DRAWING AMENDMENTS

REMARKS

RF POWER LDMOS TRANSISTOR WITH MULTIPLE GATE FINGERS

Inventors: Jan Johansson et al. Attorney Docket.: 068758.0136

Fig. 1

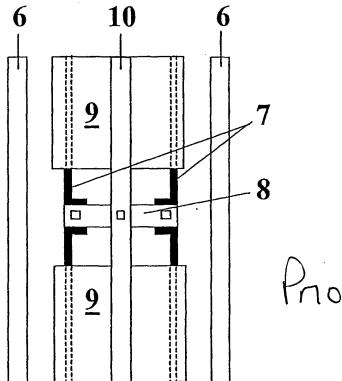
The drawings were objected to for failing to show every feature of the invention as specified in the claims. Please replace Drawing Sheets 1, Figures 1-2 with replacement Drawing Sheets 1, Figures 1-2. Applicants also submit annotated red-lined drawing pages reflecting the changes. Applicants provide formal corrected drawings to be entered if the proposed changes are accepted by the Examiner.

Examiner has objected to the drawings for not showing every feature of the invention specified in the Claims under 37 CFR 1.83(a). Applicants enclose substitute drawings for the Examiner's review and approval.
